400MW Richards Bay Power Facility on Erven 17455, 17443 and 17442 within the Richards Bay Industrial Development Zone, KwaZulu-Natal Province

Motivation for amendment of the Environmental Authorisation

DEA Ref.: 14/12/16/3/3/2/867

September 2020

Figure 2.2. Updated layout map (version 1) with environmental sensitivities, as per condition 14 and 15 of the EA.

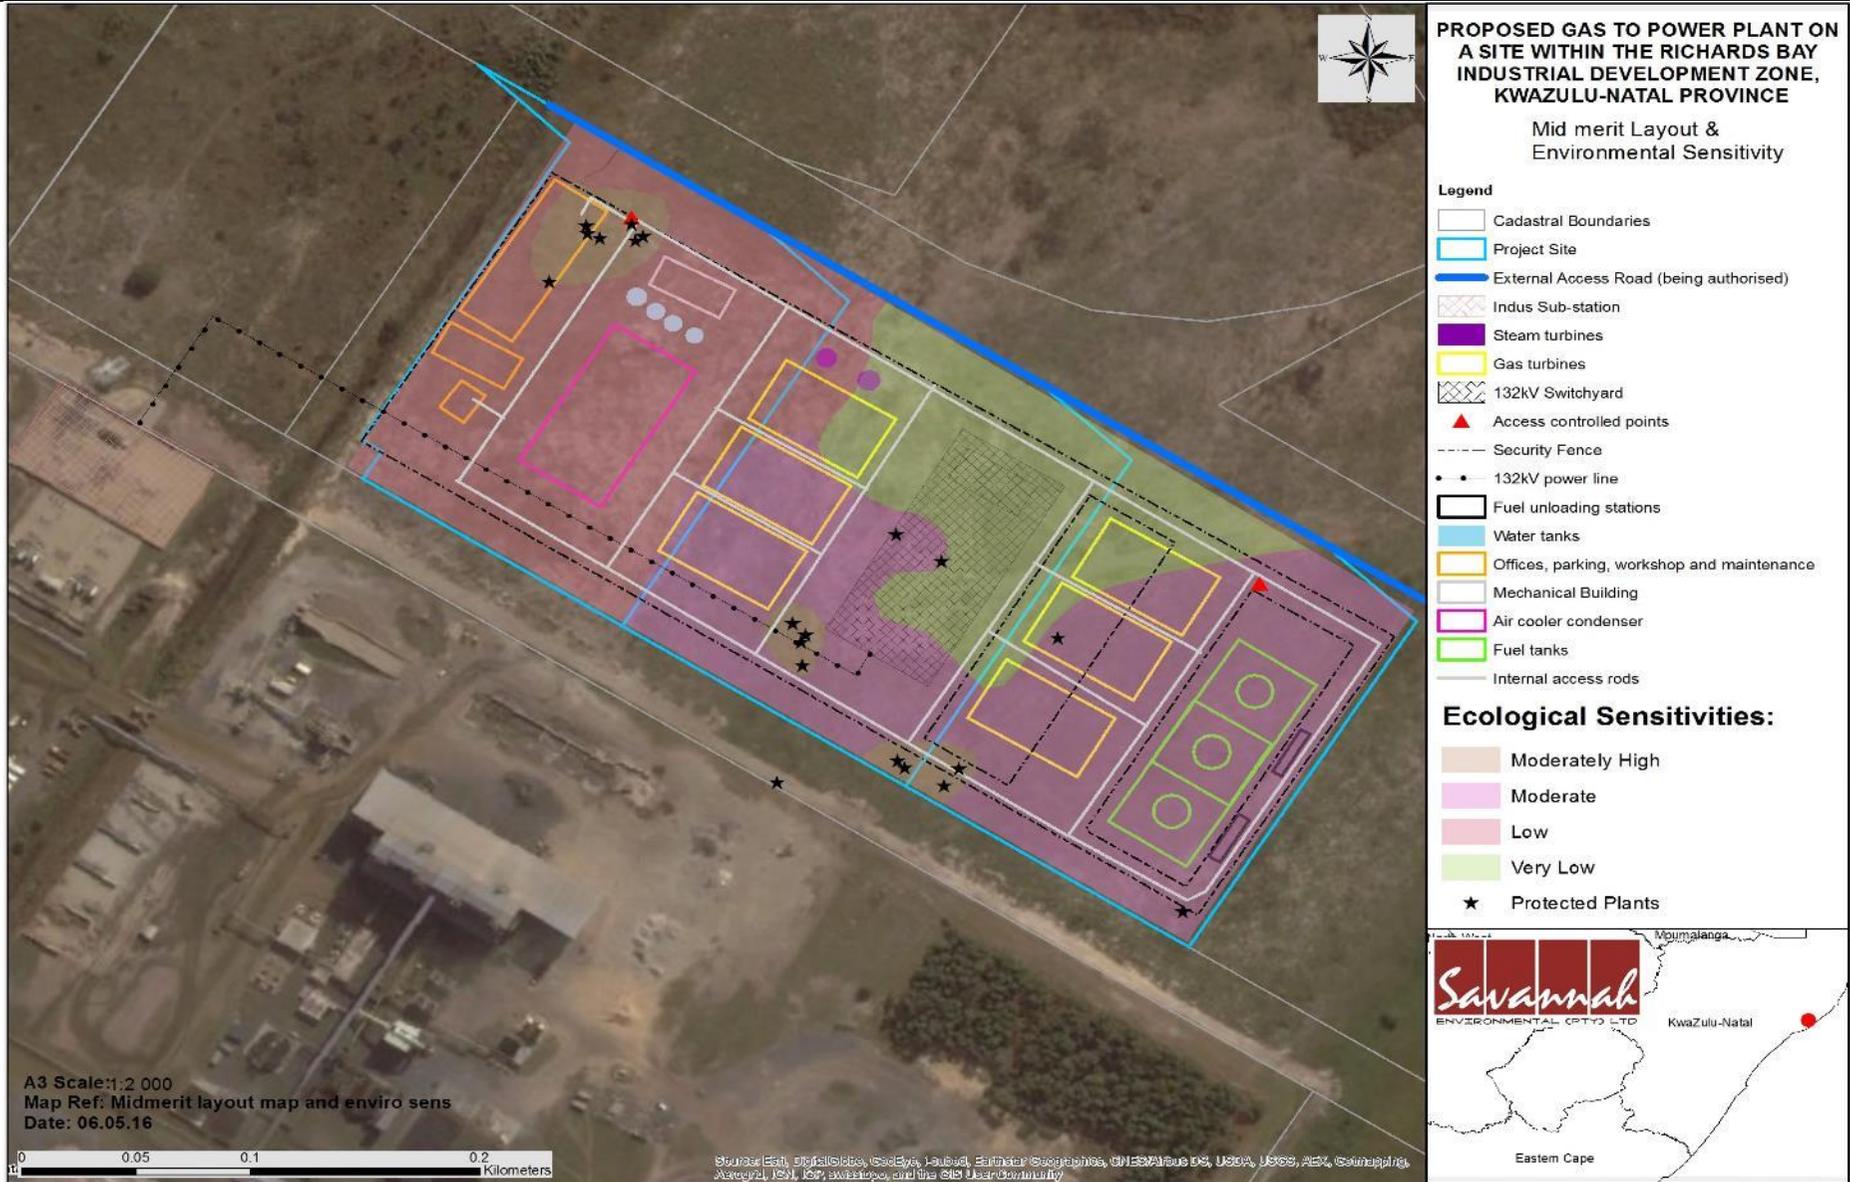
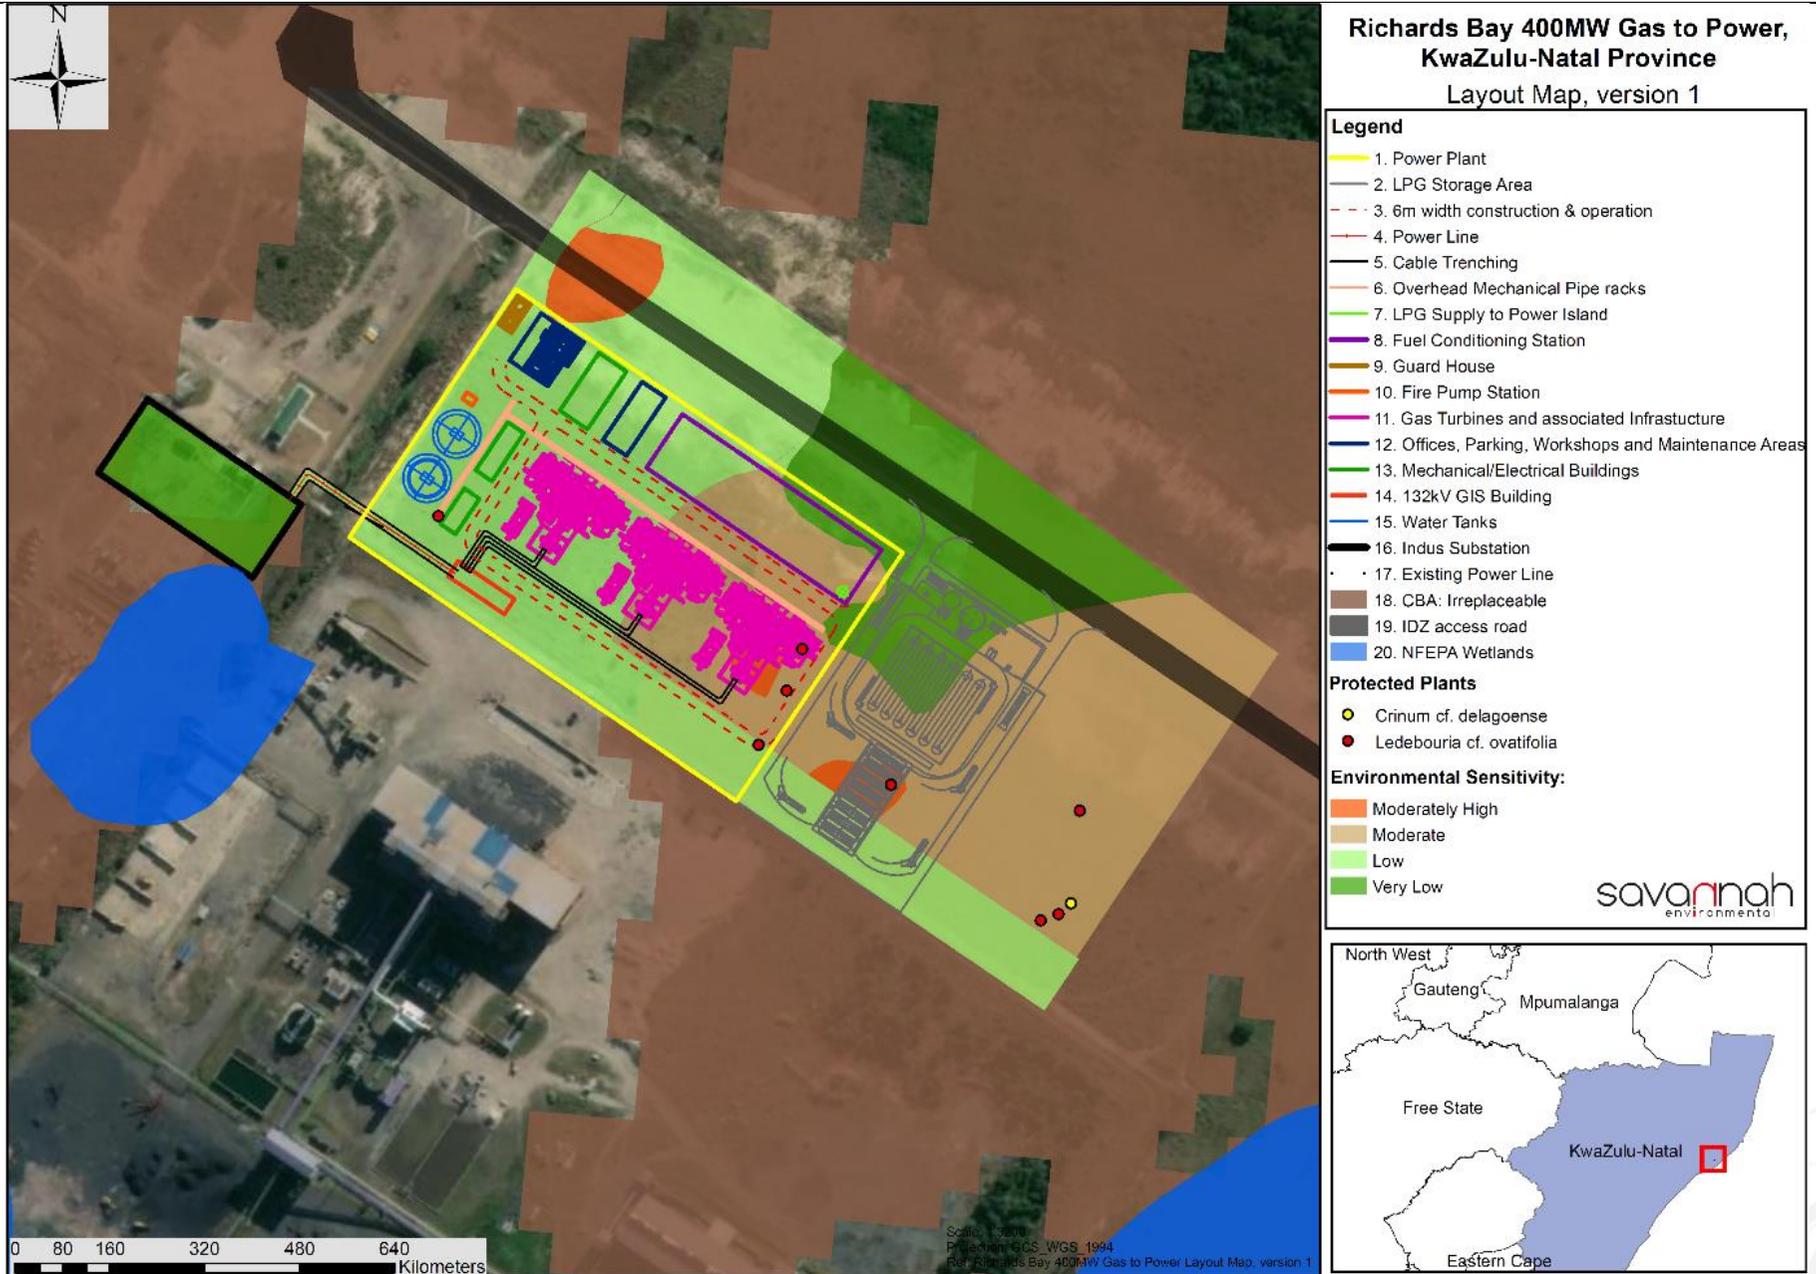
no layout updates have been conducted since the issuance of the Environmental Authorisation, and therefore the layout map (Figure 2.1) submitted along with the final EIR is the most recent version.

In accordance with condition 14 and 15 of the EA however, a final layout must be submitted to public participation and then submitted to the DEA for final approval, as it was not approved in the initial issuance of the EA. Furthermore, in accordance with conditions 15,16,17,18,19 and 20 of the EA, the EMPr submitted with the EIA was not approved and therefore similarly required update and a 30 day public review, followed by submission to the DEA for final approval. This process will be completed as part of this amendment process, and the EMPr and Layout updated as per conditions 15,16,17,18,19, 20 and 14,15 (respectively). Therefore, these requirements are requested to be amended to reflect the approved status of the EMPr and Layout. The following changes are thus requested:

The updated EMPr, Revision 1 dated September 2020 (refer Appendix F) and the updated layout, version 1 dated September 2020 (Figure 2.2) has now been included into the report for review and comment by the public, and consideration of the authority.

The applicant has now updated the EMPr (refer Revision 1 dated September 2020 attached in Appendix F of this report) and the updated layout (refer version 1 dated September 2020 included as Figure 2.2 in this report), which is now, along with this Motivation Report, being released to the public and key stakeholders for a period of 30 days. Public comments received will be considered and will be submitted along with the final Motivation Report for authority decision making.

In addition, as required in terms of conditions 14 and 15 of the EA, the updated layout is now included in Figure 2.2 of this report and is available for public review prior to being submitted to the DEA for review and approval as the final facility layout.
